Agenda Item 3

590 Sheridan Road

Rear Porch Addition, Exterior Alterations and Building Scale Variance

STAFF REPORT AND RECOMMENDATION

TITLE: EXISTING SITE PLAN

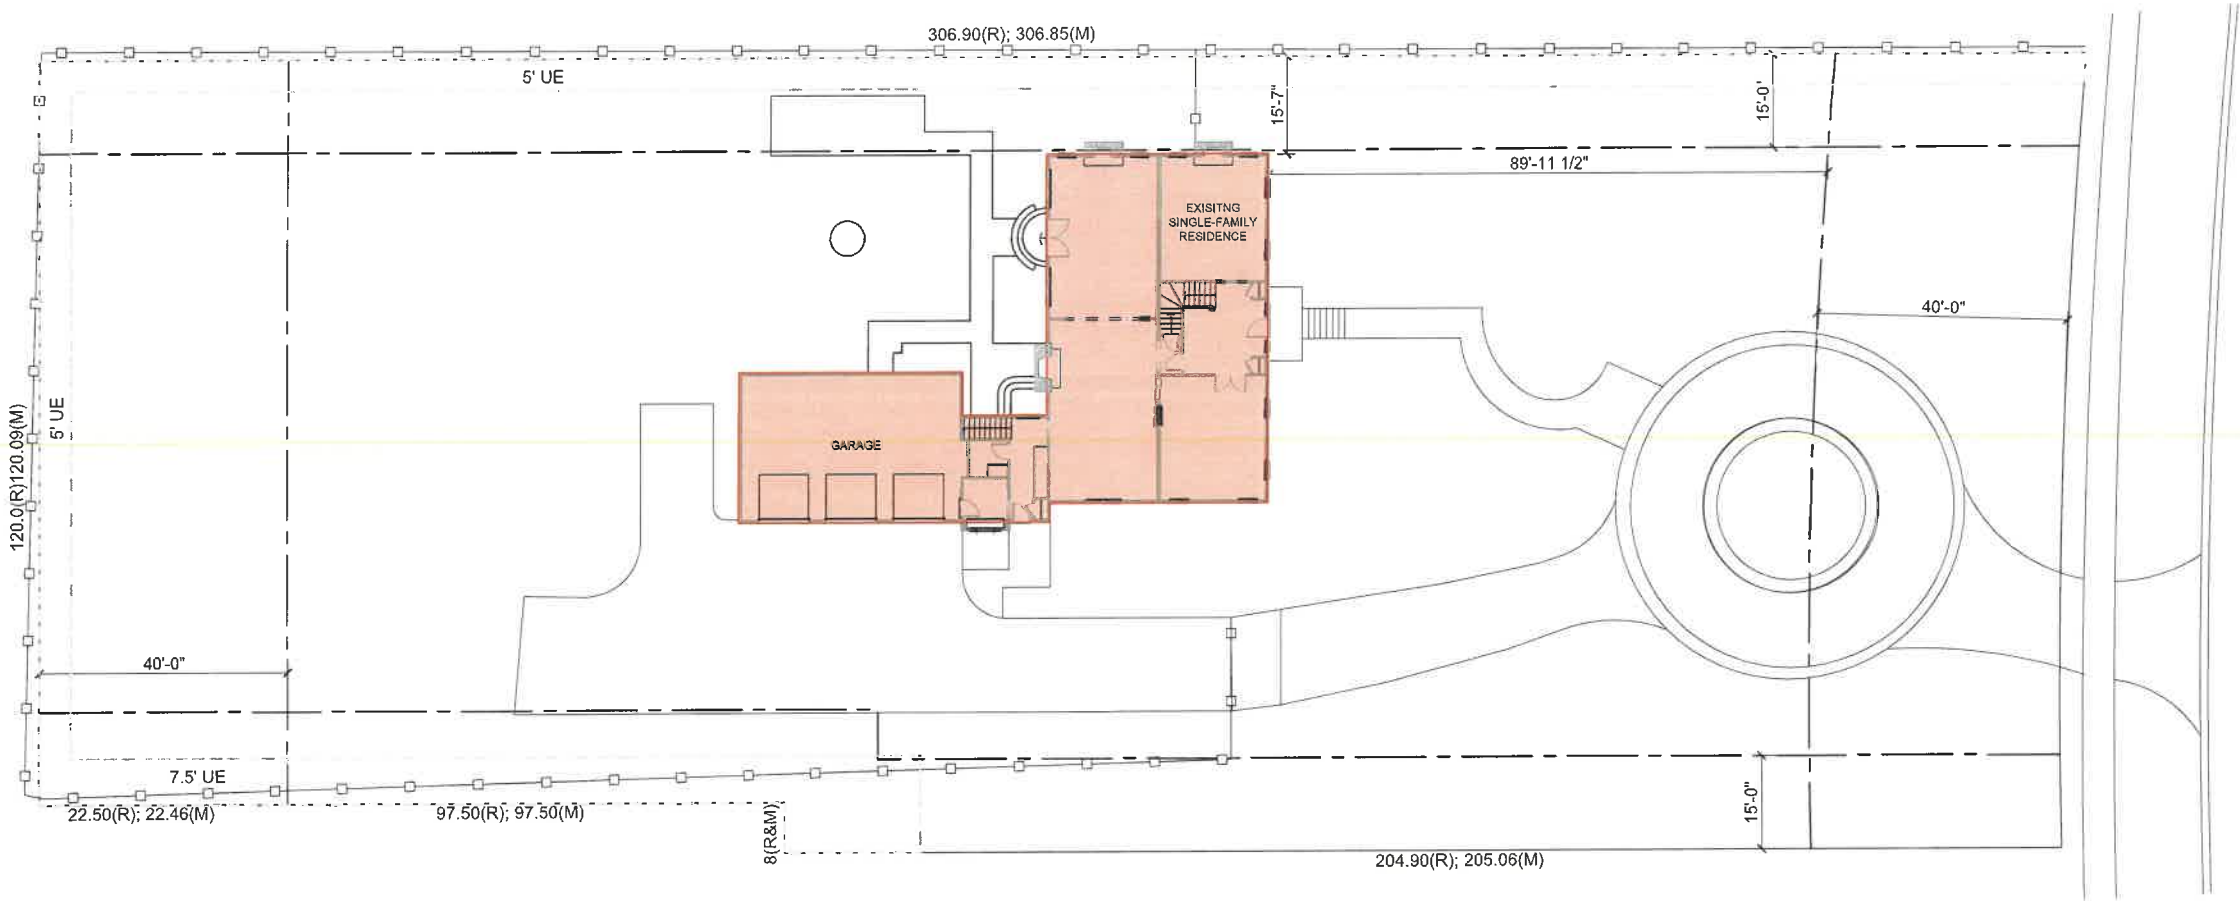
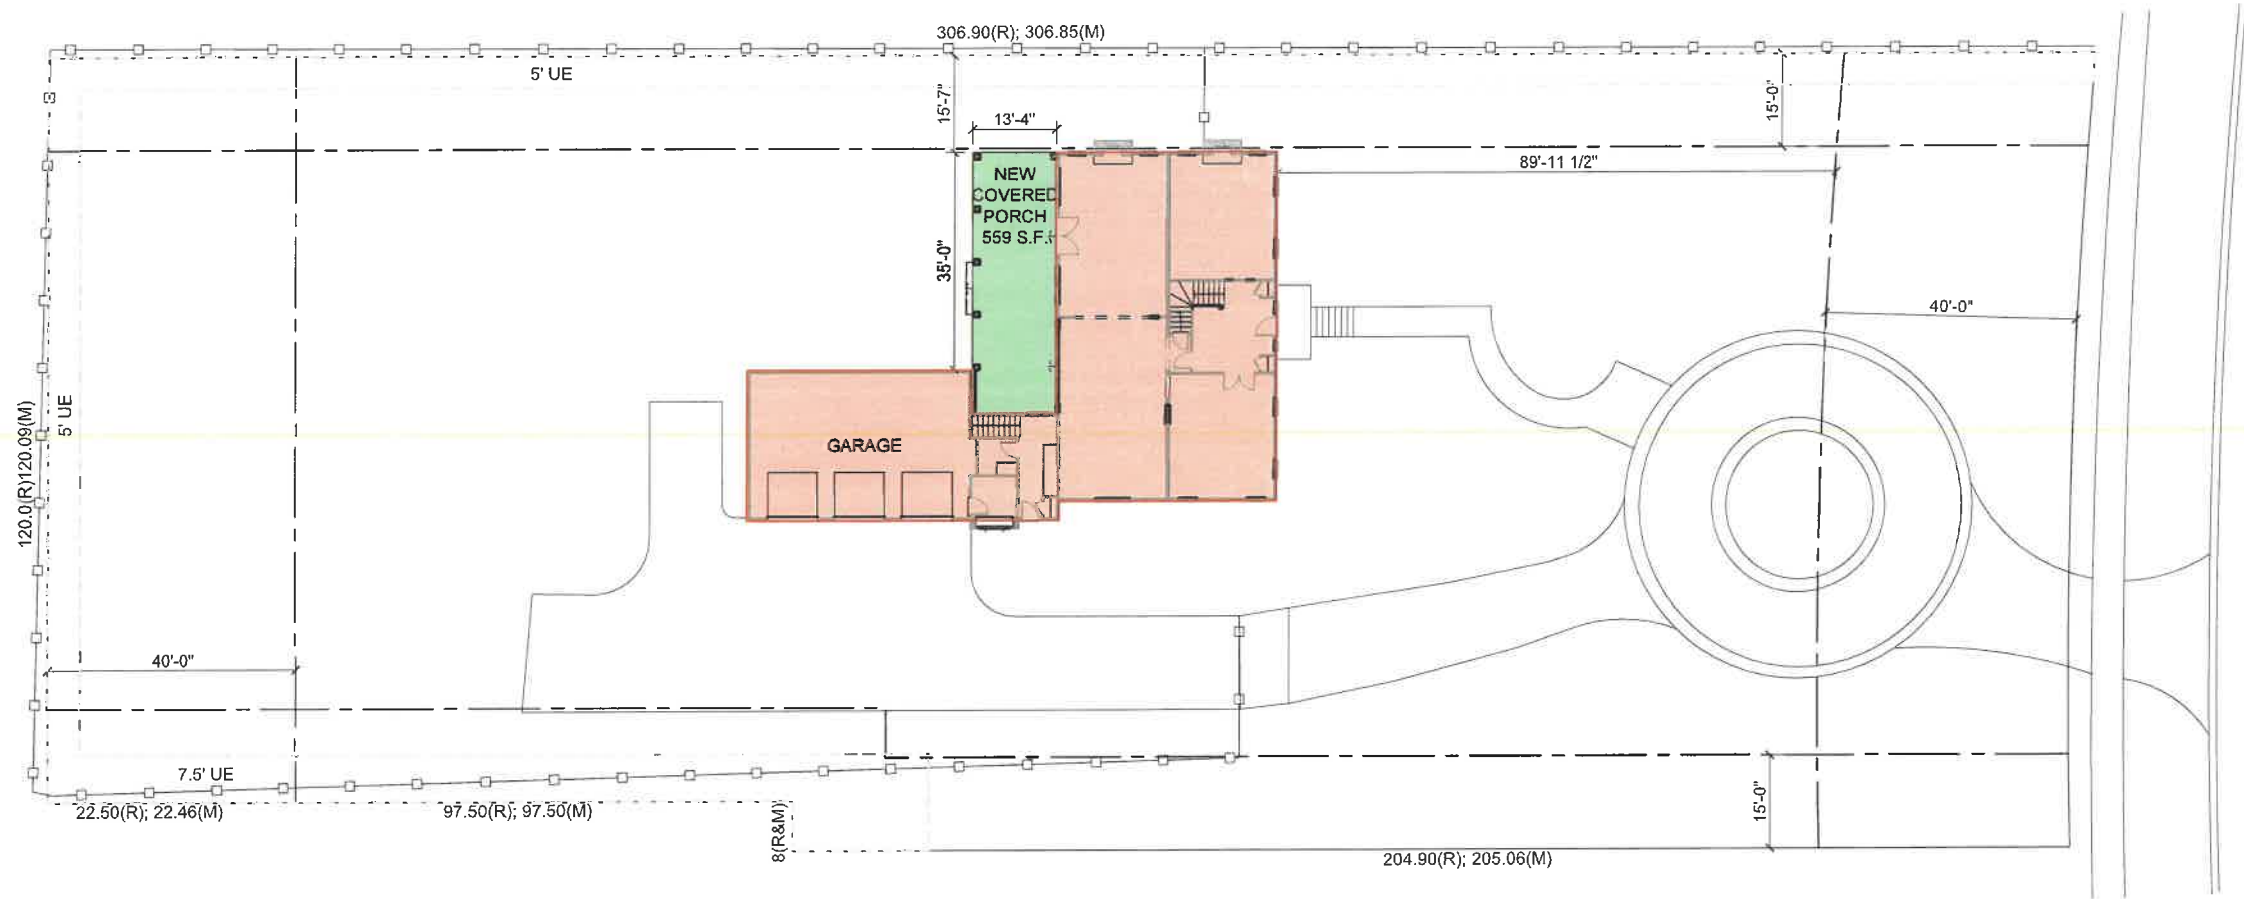
The existing stoops and walkways at the rear of the home will be removed to accommodate the proposed porch. No other changes to the hardscape on the site is proposed at this time.

TITLE: EXISTING WEST EXTERIOR ELEVATION

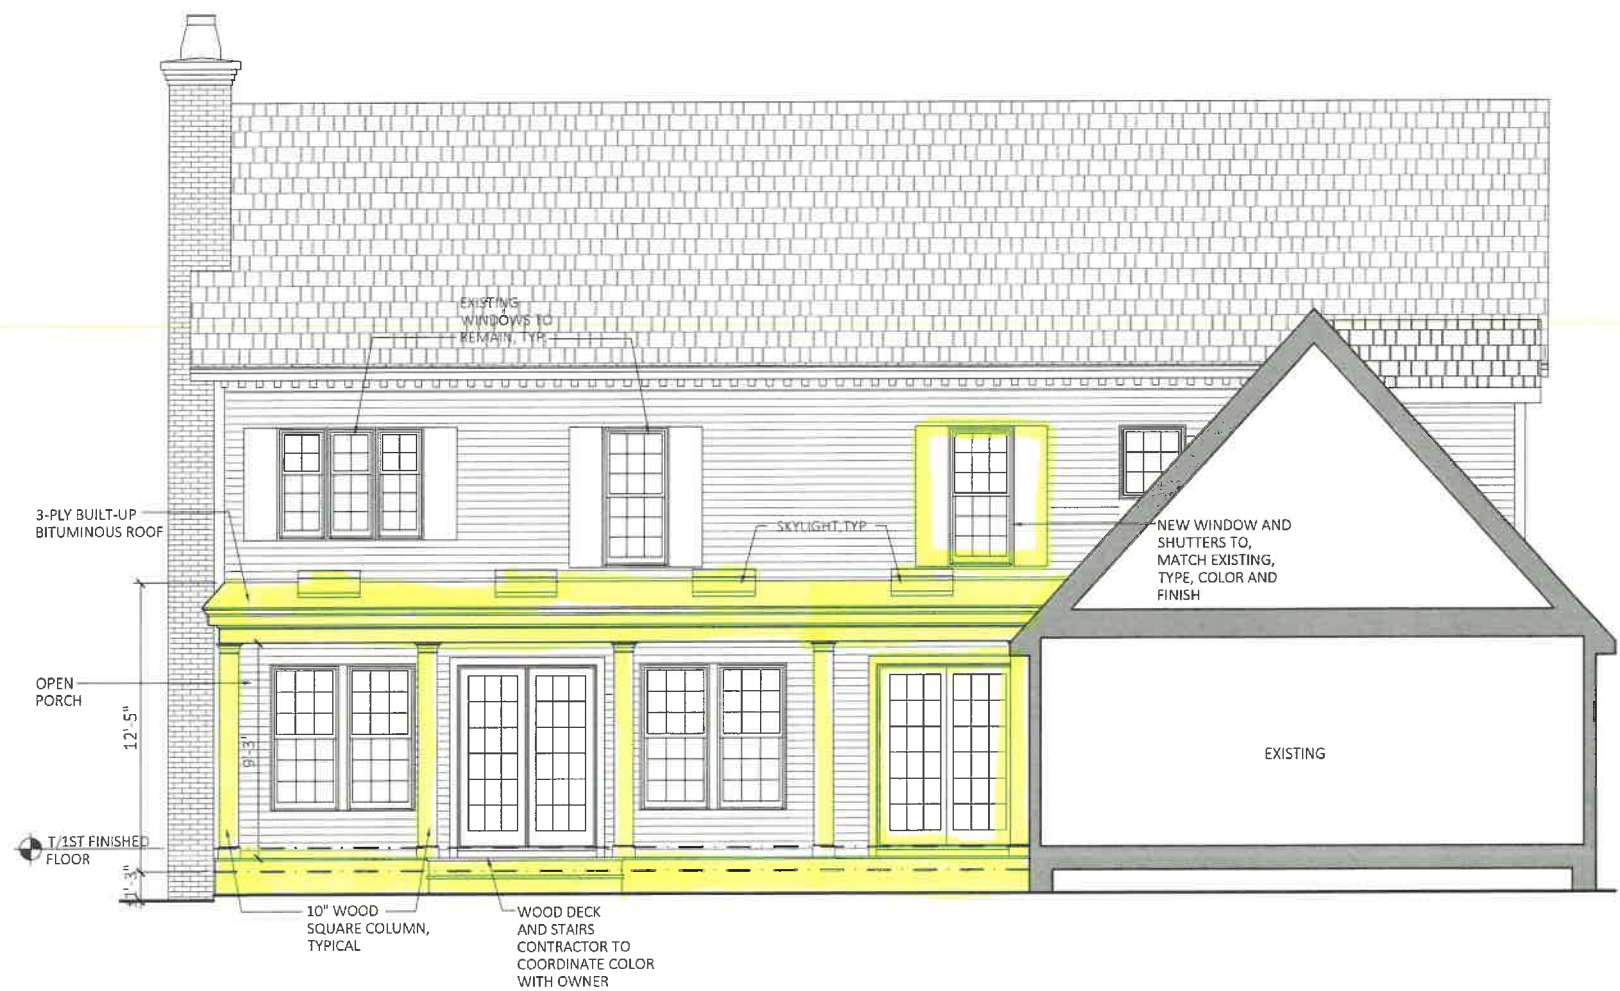
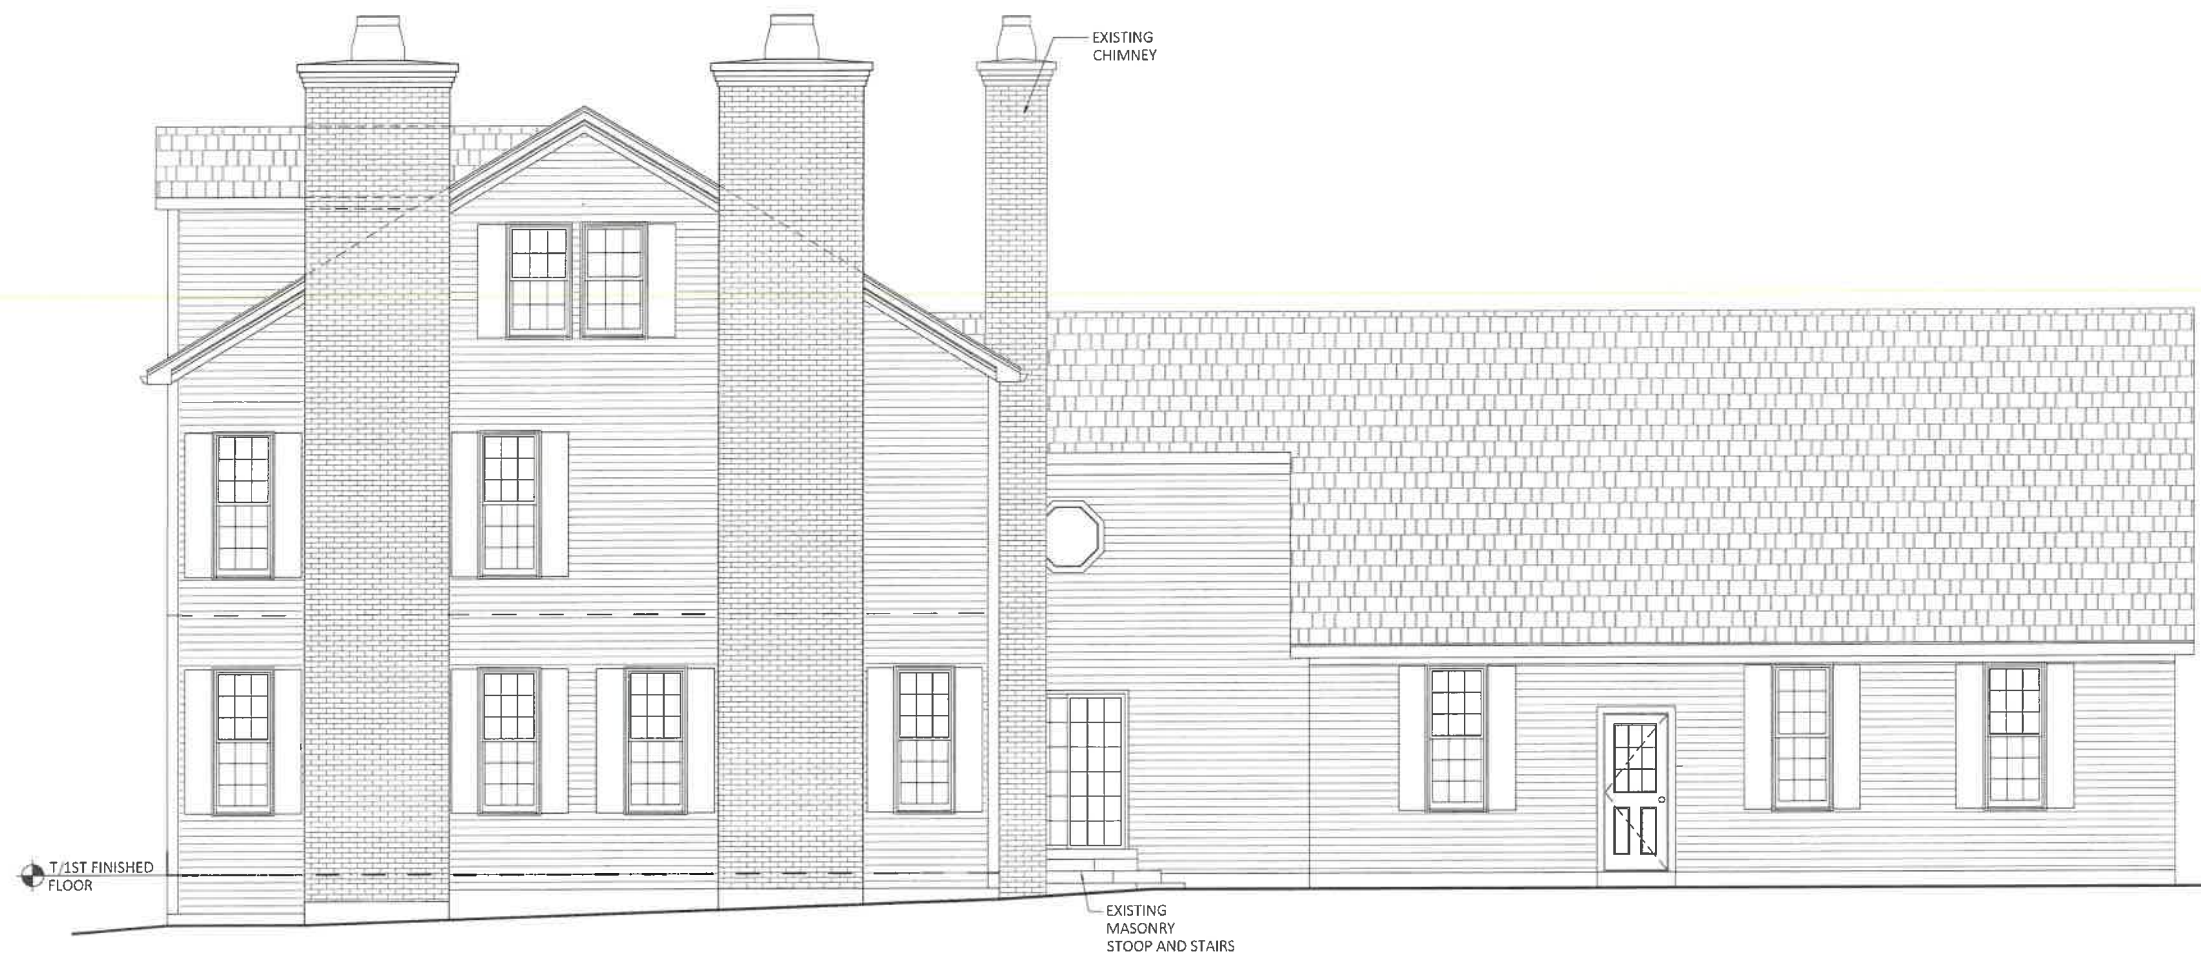
Currently, there is a brick chimney on the west (rear) side of the home that is proposed for removal. In the area of the chimney, a new French door is proposed on the first floor and a double hung

window with shutters is proposed on the second floor. The existing sliding door in the hallway between the house and the garage on the north elevation will be removed and replaced with a double hung window to match the other windows on the home.

This standard is met. The porch will have wood columns, fascia, and soffits. A modified bitumen roof is proposed. Aluminum clad windows with interior and exterior muntins are proposed.

This standard is met. The porch has a simple shed style roof. The low-pitch of the porch roof is necessary in order to avoid interfering with the second floor windows.
